# Staff Report

**Re:** PLNHLC2021-00967 New Construction and PLNHLC2021-00966 Special Exception at 237 N. Almond Street

## NEW CONSTRUCTION AND SPECIAL EXCEPTIONS IN A HISTORIC DISTRICT

**A2 BUILDING SECTION**  
1/4" = 1'-0"

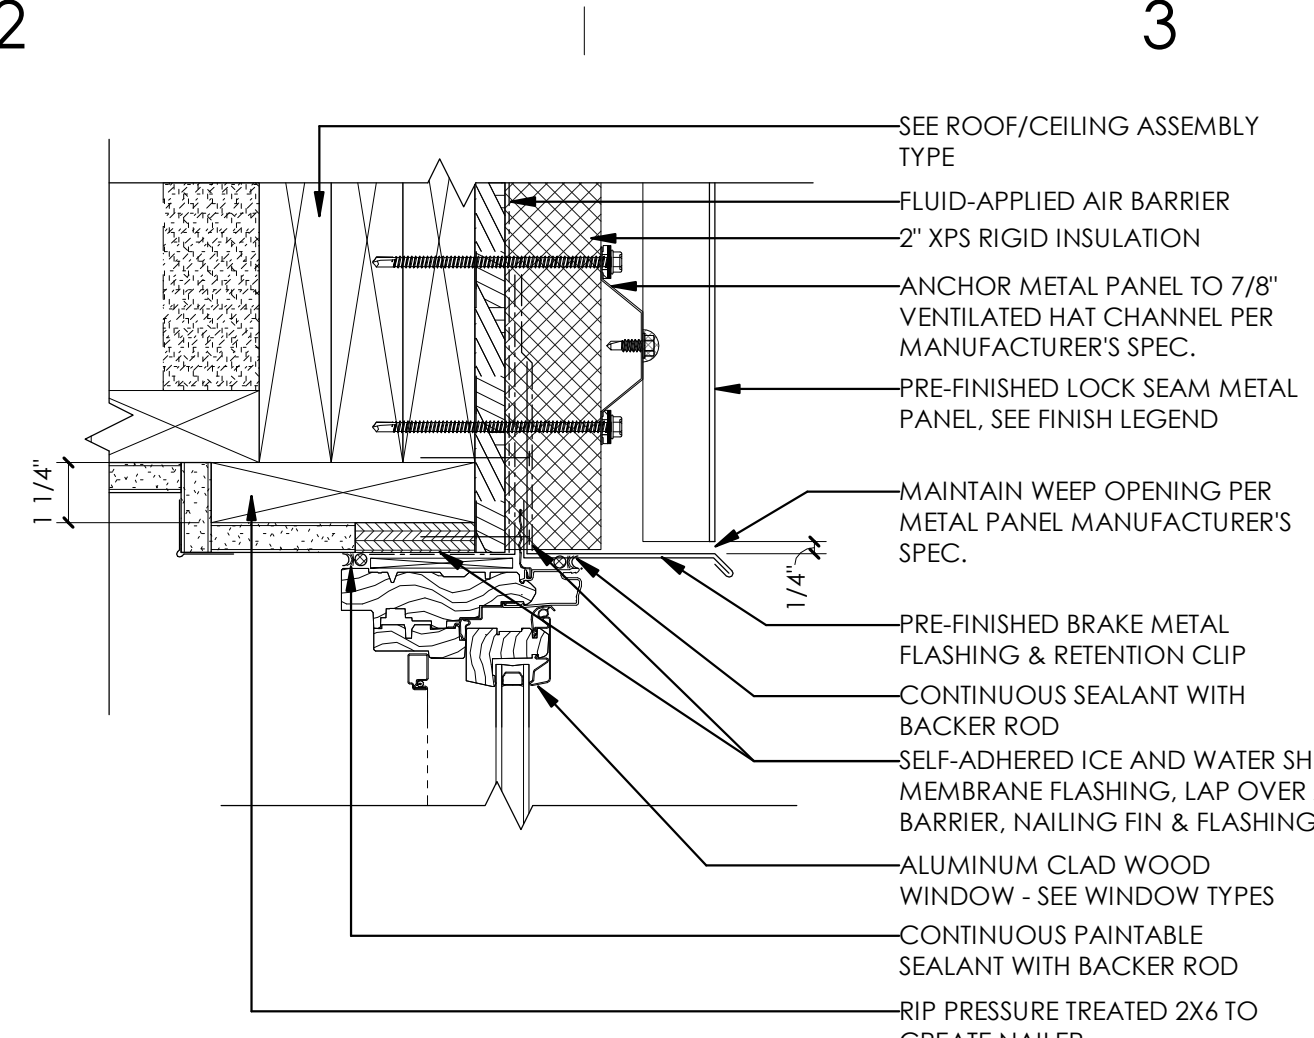
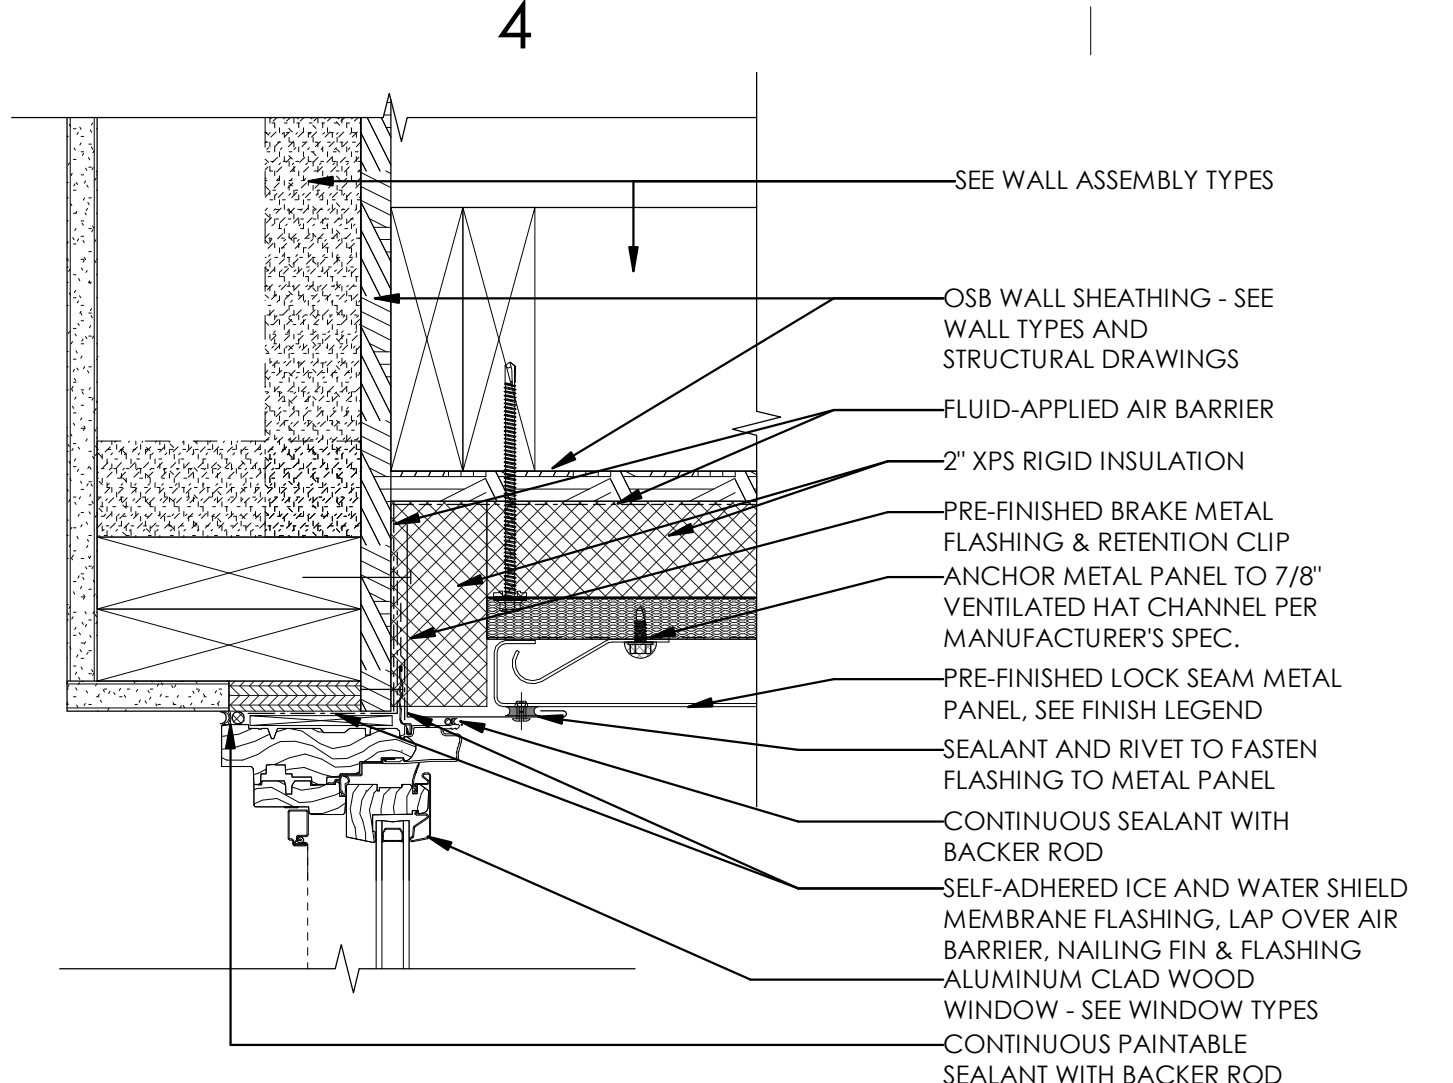
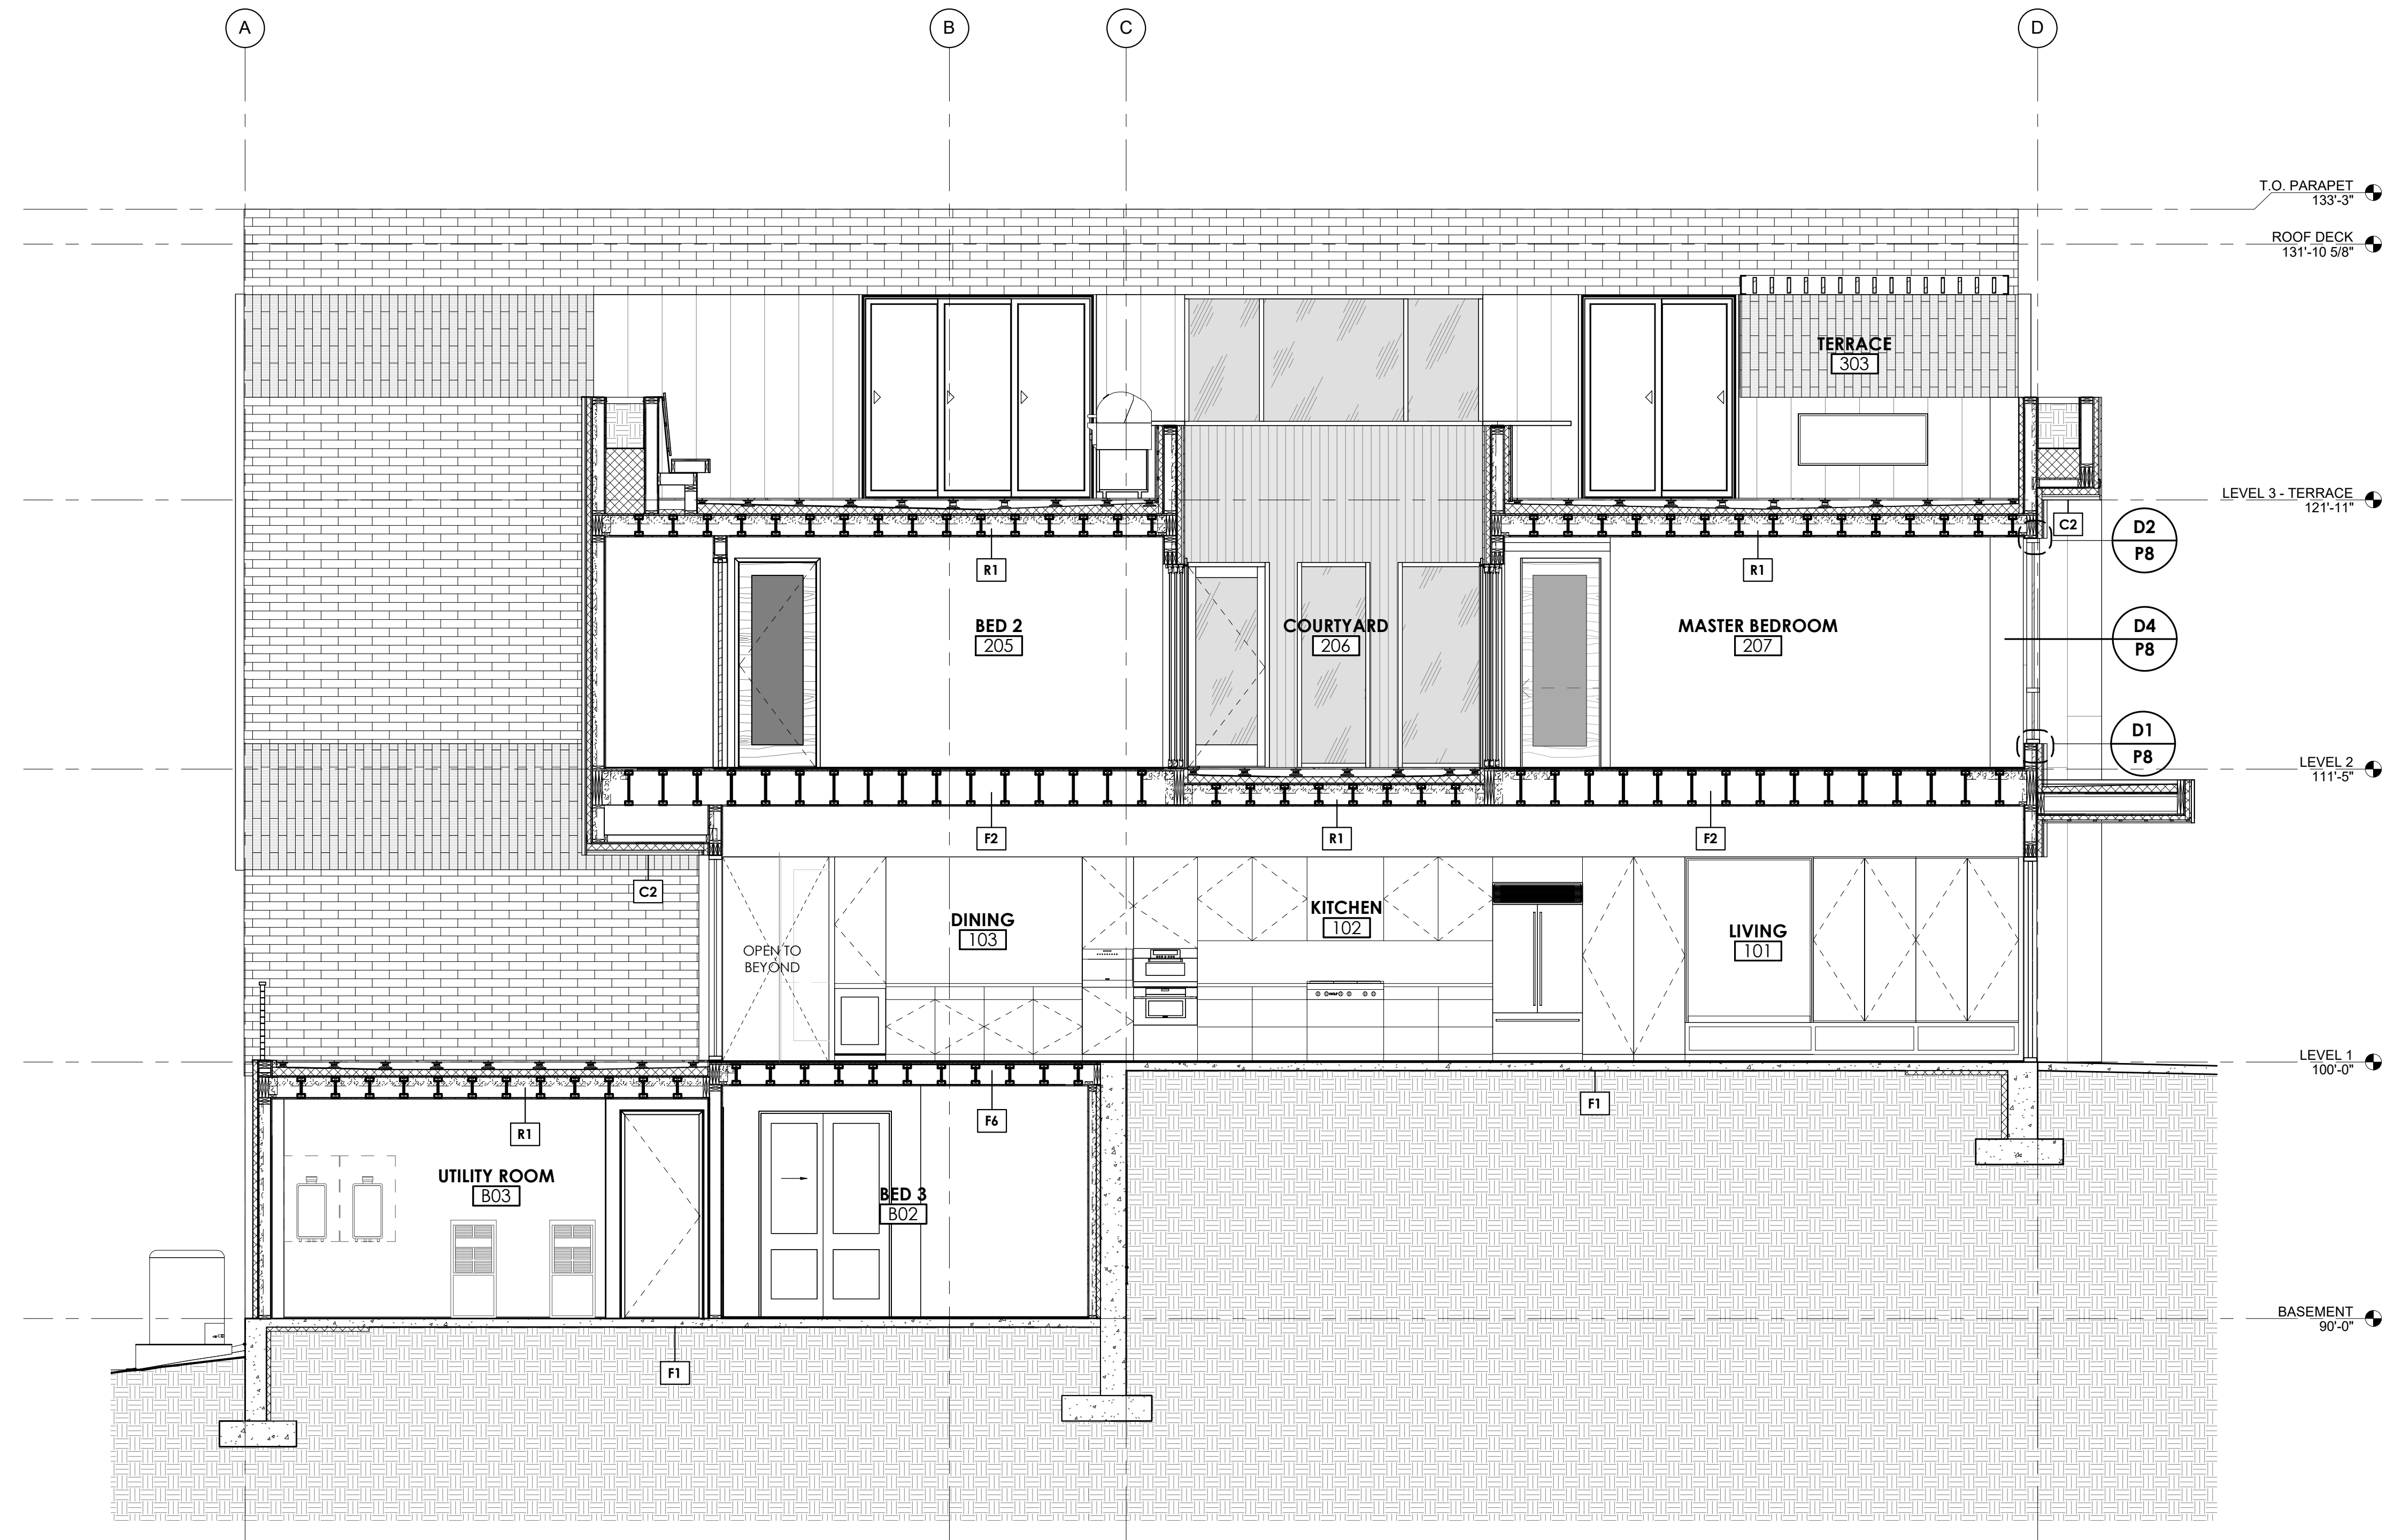
*- Identify the materials for windows, door, and garage on plans. Provide a section drawing that includes a window.*

Please refer to added keyed notes outlining that all windows and doors are to be aluminum-clad wood architectural windows and doors. The garage door is also keynoted to reflect that it is to be an insulated steel flush panel sectional door on updated elevation drawings. Please refer to provided preliminary section drawing, as requested, reflecting a typical window as well as reflecting the front entrance door/canopy. Structural coordination is ongoing and may impact certain elements of the section but the intent for fenestration is anticipated to remain generally consistent through the remainder of design development & construction documentation.
